Table of Contents for Carpenter Hall Site Plan
Heritage Tree Variance Package

**ITEM FOR PLANNING COMMISSION AGENDA****COMMISSION****DATE REQUESTED:** January 10, 2017**ADDRESS****OF PROPERTY:** 400 Josephine Street**SITE PLAN #:** SP-2016-0073**NAME OF APPLICANT:** Stantec, Inc. (formerly Bury, Inc.)**CITY ARBORIST:** Keith Mars, 512-974-2755
keith.mars@austintexas.gov**ORDINANCE:** Heritage Tree Ordinance (LDC 25-8-641)**REQUEST:** The applicant is requesting to remove two heritage trees, each with a single-stem greater than 30" in diameter.**STAFF****RECOMMENDATION:** The request meets the City Arborist approval criteria set forth in LDC 25-8-624(A)(2), thus the variance is recommended.

SITE PLAN: The Carpenter (SP-2016-0073C)

REQUEST: The applicant is requesting to remove two heritage trees, each with a single-stem greater than 30 inches as allowed under LDC 25-8-643

Exhibit 1

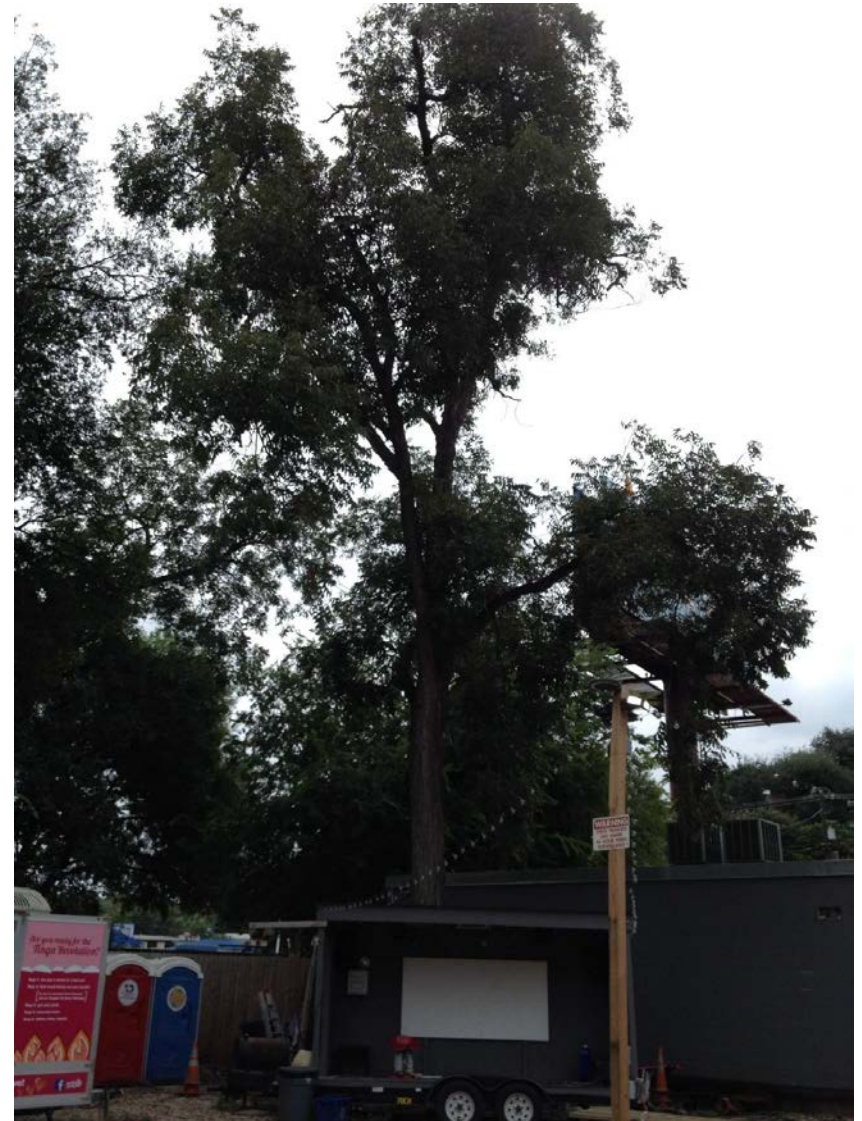
Both canopies display minor to major asymmetry as a result of prior limb failures (Exhibit 1). Storm damage is evident in the canopy as most leaders have abrupt termination of the tapering to branches (Exhibit 2). Tree #908 displayed a heightened

EXHIBIT A EXISTING CONDITIONS

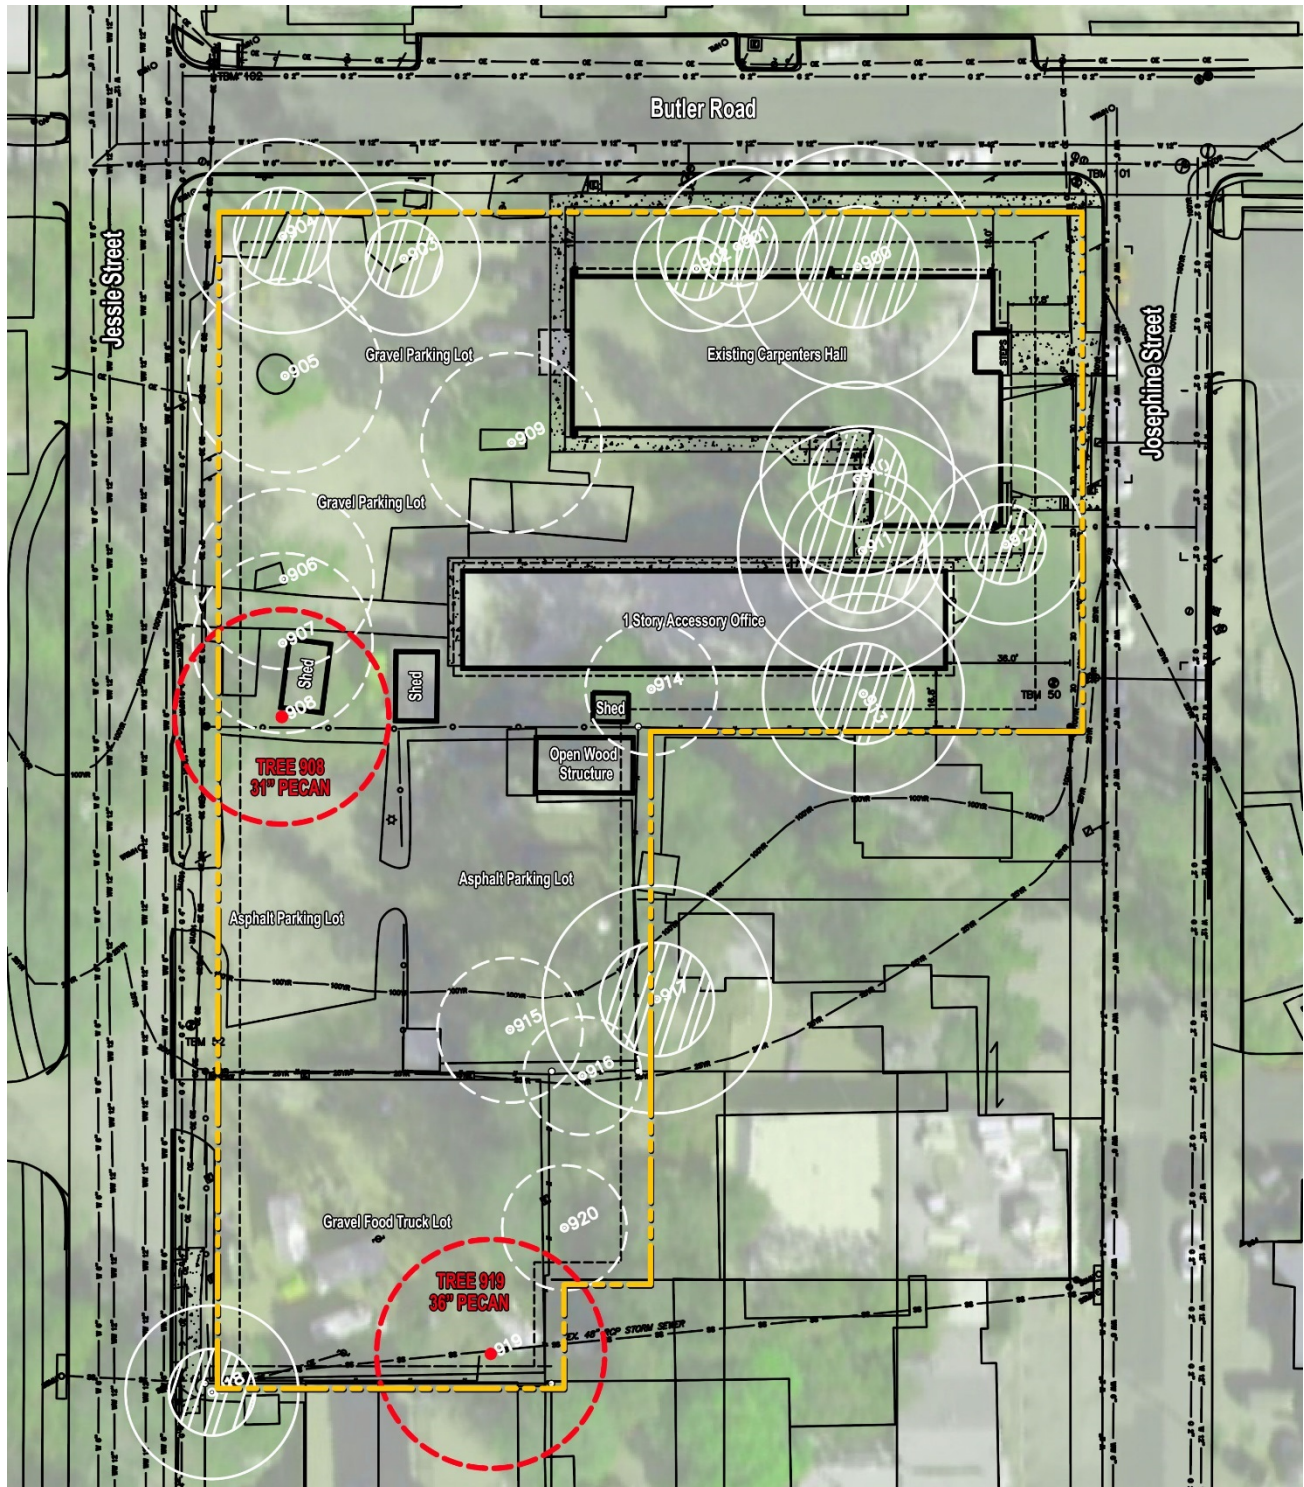
There are currently two heritage trees on the site being requested for removal, (1) 31" Pecan and (1) 36" Pecan (EXHIBIT A).

EXHIBIT B PRELIMINARY SITE PLAN

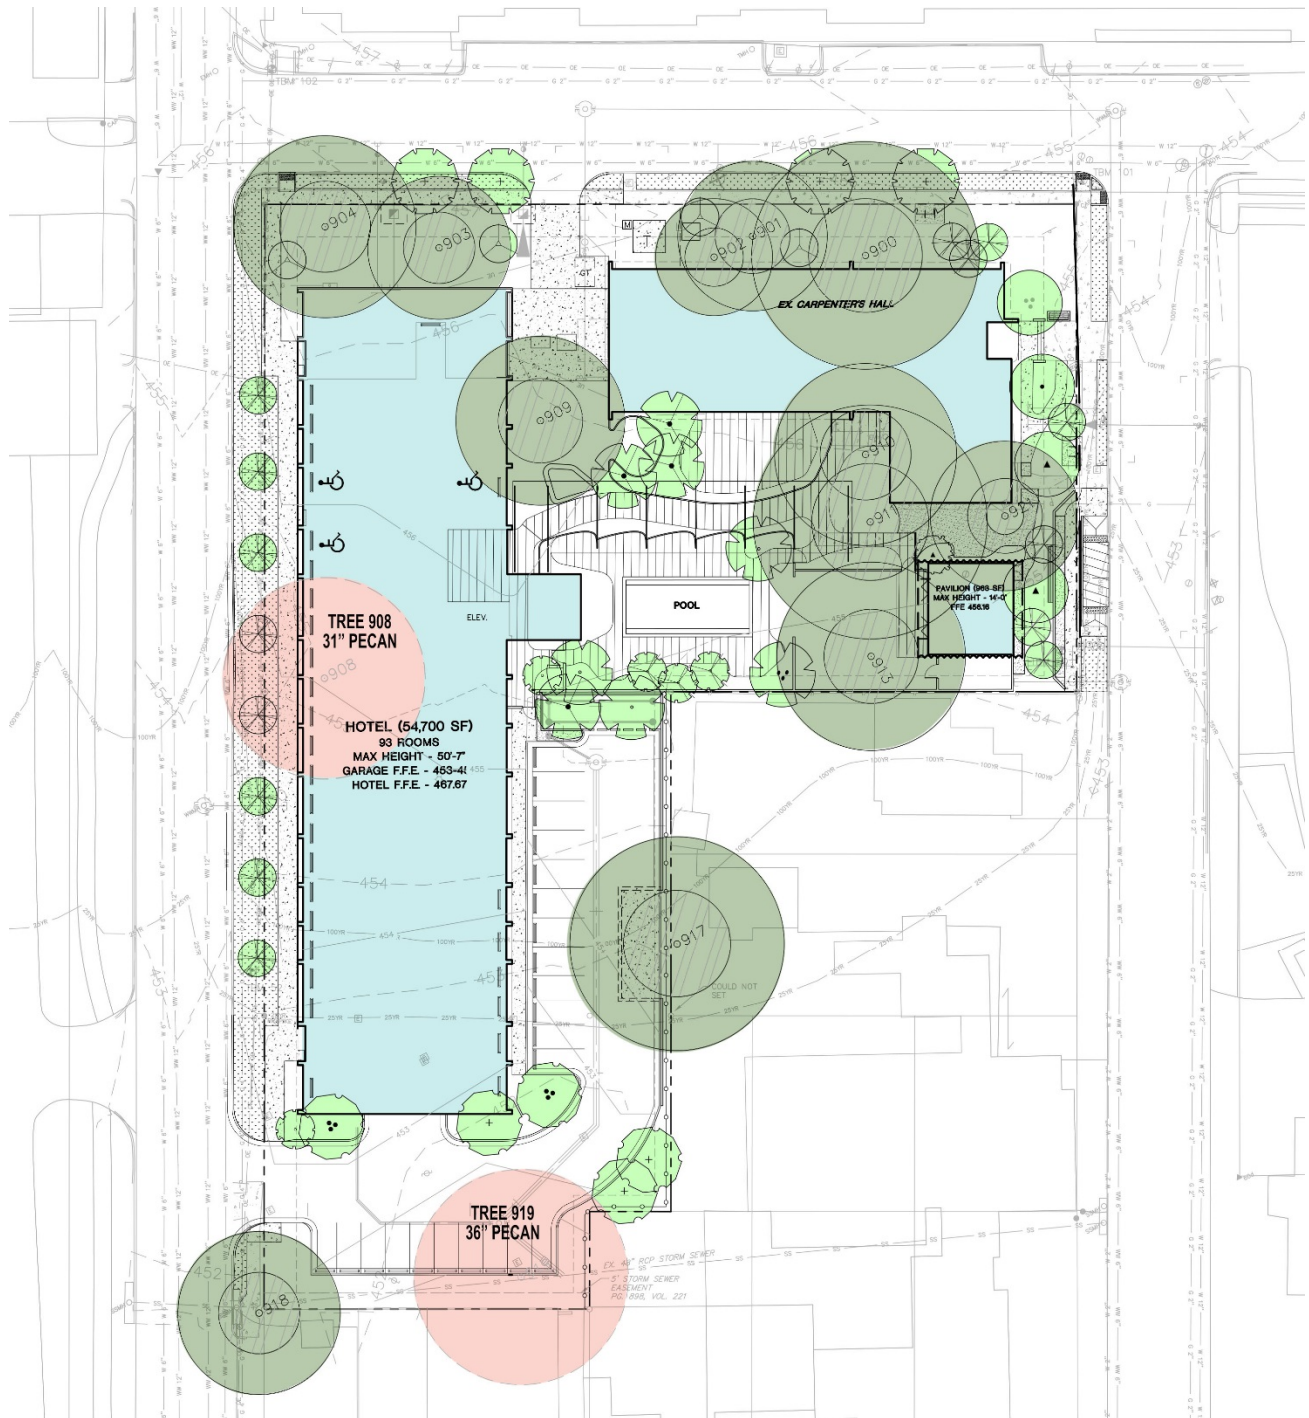
Tree 908, a 31" Pecan, depicted on (EXHIBIT B), is being requested for removal based on the limitations of how the site can be developed, and its potential risk to the public.

Tree 919, a 36" Pecan, depicted on (EXHIBIT B), is being requested for removal based on the condition of the tree, and its potential risk of causing personal injury, property damage, or both.

Tree #908: West stem tomograph near crotch at 9.5 feet above grade showing 31% decay

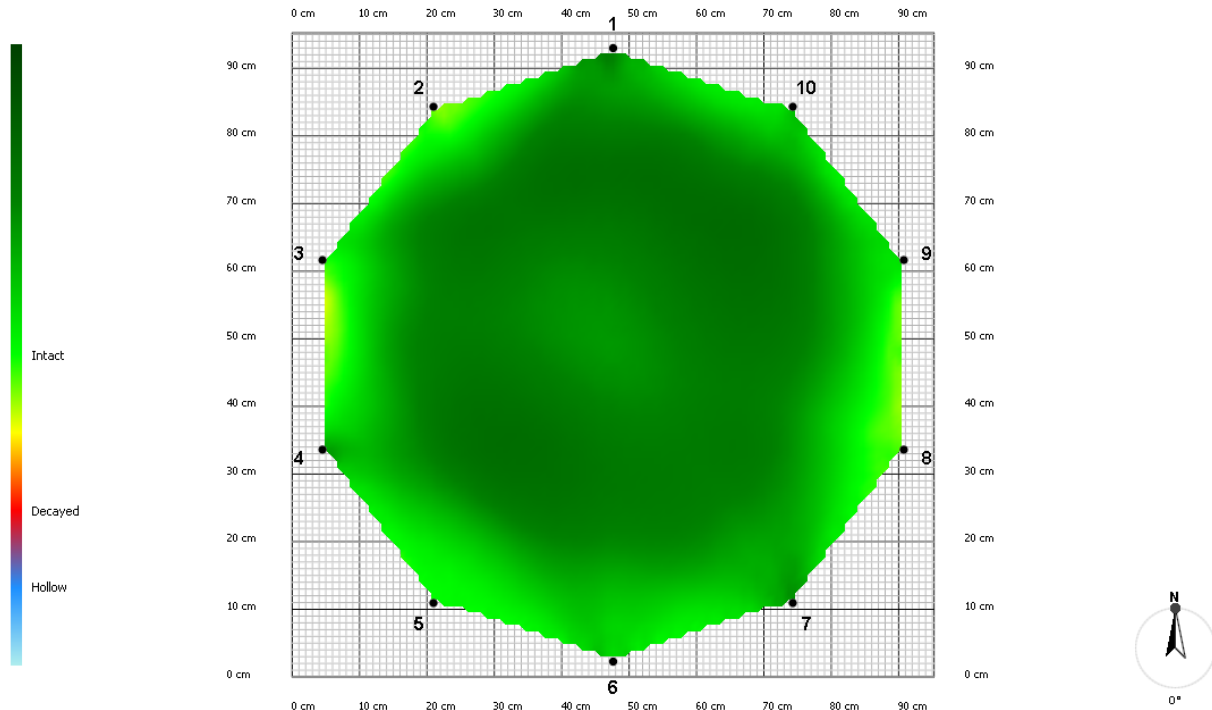
Regarding the west stem in particular, while solid wood appears mostly to surround the decay column, the decay does connect to the exposed cavity, which is large. This condition makes it likely that the decay will increase faster than wound closure. The location of this decay just above the crotch of the main stem also creates concern. The load on the west stem is *significant*, and the likelihood of failure for this tree part is *probable*.

- Remove the west stem.
- Prune the remaining tree to reduce weight at branch ends and to clean the canopy of dead branches one inch in diameter and greater.
- Install support cabling in the upper third of the canopy to provide mechanical support to weak branch unions to reduce risk of failure.
- Aerate the soil within the entire CRZ with a specialized tool, such as an Airspade, to reduce compaction.
